4 October 2022

Transport for NSW
231 Elizabeth Street
Sydney NSW 2000

The National Trust object in the strongest possible terms to the Central State Significant Precinct Rezoning Proposal in its current form. We agree with the Statement of Heritage Impact (p.164) that *“Overall, the proposed masterplan development would have a cumulative major and detrimental impact to the significant cultural landscape of the Central Station Precinct.”*

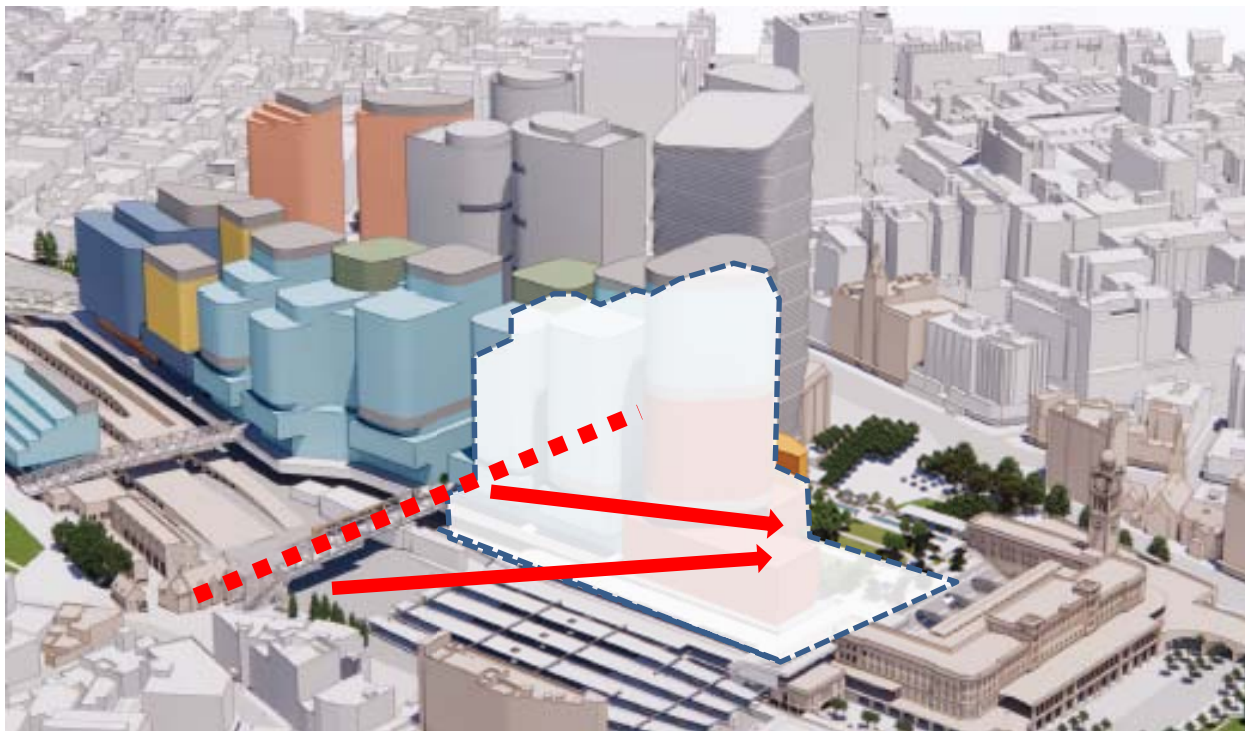
This is absolutely the case, yet instead of making it the centrepiece of the precinct, the new views of the terminal itself from the east-west concourse described as the "Devonshire Link" will be blocked by large towers of up to 39 storeys, and the arrival to the station by train as part of the "iconic entry" with a view of the clock tower will be buried underground with no connection to the actual outside environment at all.

The National Trust agree with the assessment of the Heritage Impact Statement that the proposed open-air cross link above the Devonshire Street Tunnel, known as the "Devonshire Link" would have a generally positive contribution to the precinct by spanning across the Central Yards connecting the OSD and western perimeter to the east, terminating near the Railway Institute Building.

The benefits of this link are however compromised by the North OSD element of the proposal. The Devonshire Link could form an excellent opportunity to access the Country and Intercity platforms from the south whilst reinforcing the civic importance of the Central Terminal Building to those arriving as pedestrians or train passengers.

253 North-south section - Central Green and A1 tower development parameters

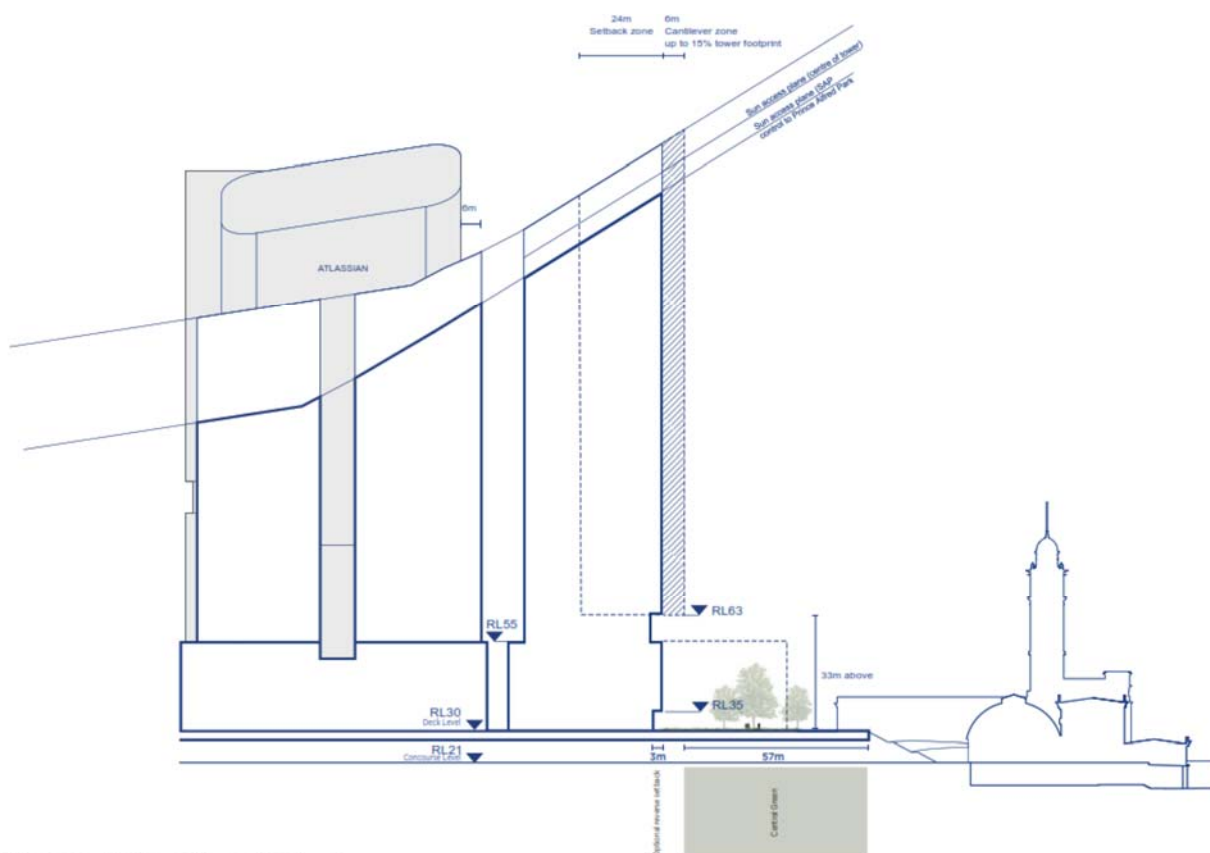
The very real opportunity to “re-establish the civic role of the Sydney Terminal Building” and let it “become the centrepiece of the precinct” will be prevented by building a series of towers of 21-39 storeys to the north of the proposed Central Walk as part of the North OSD. (Source: Architectus, with National Trust overlay)

The scale of the proposed North OSD and its towers is almost beyond belief, and does not respect the Central terminal or its clock tower at all. The towers are so large and so elevated, that even their podium at RL 63m is almost as tall as the clock tower. (Source: HIS, p.124)

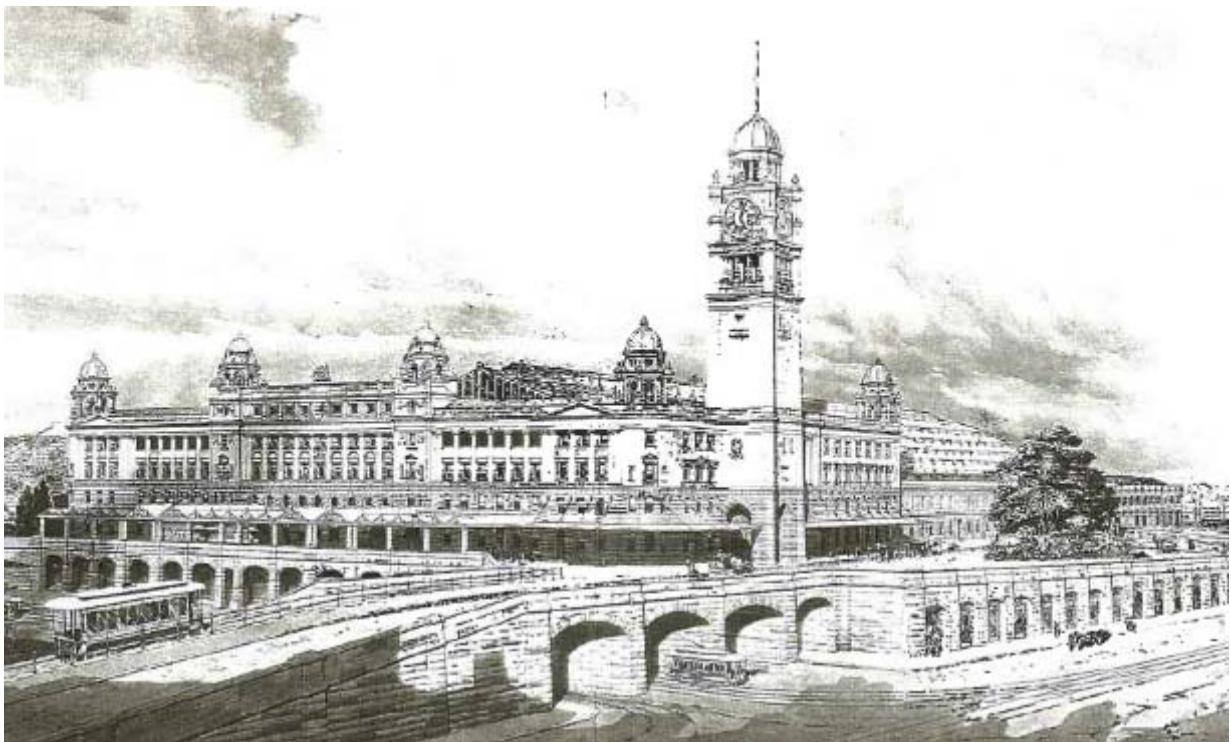
Covering of the platforms

Central Station has long played an important role as a defining feature and arrival point for Sydney, as was originally intended by NSW Government Architects Walter Liberty Vernon and George McRae who were responsible for its design. The former NSW Government Architect Chris Johnson describes Central as Vernon's "principle contribution to Sydney's civic domain" and noted that its design "marked a gateway at the southern end of the city."⁶ Peter Webber, another former NSW Government Architect, also notes the station as a key arrival element in the city, where "the clock tower of the Central Railway Station, symbolizing the arrival point for long distance trains to the city, serves also as a marker for those arriving by road along the principle arteries."⁷

Vernon's original design for the station (seen below) of course included a very large glazed canopy above all of the terminating platforms, but this was never completed. Such a design is of course entirely consistent with the design approach to large railway terminals all over the world – both historically and in contemporary station design and renewal, providing a large, light-filled public space befitting a major transport terminal.

The current proposal for Central Station totally ignores this historic precedent, demotes the arrival sequence to a less than suburban quality, and prevents forever the opportunity for a marvellous contemporary architectural glazed roof being erected at Central Station to facilitate a truly magnificent arrival sequence.
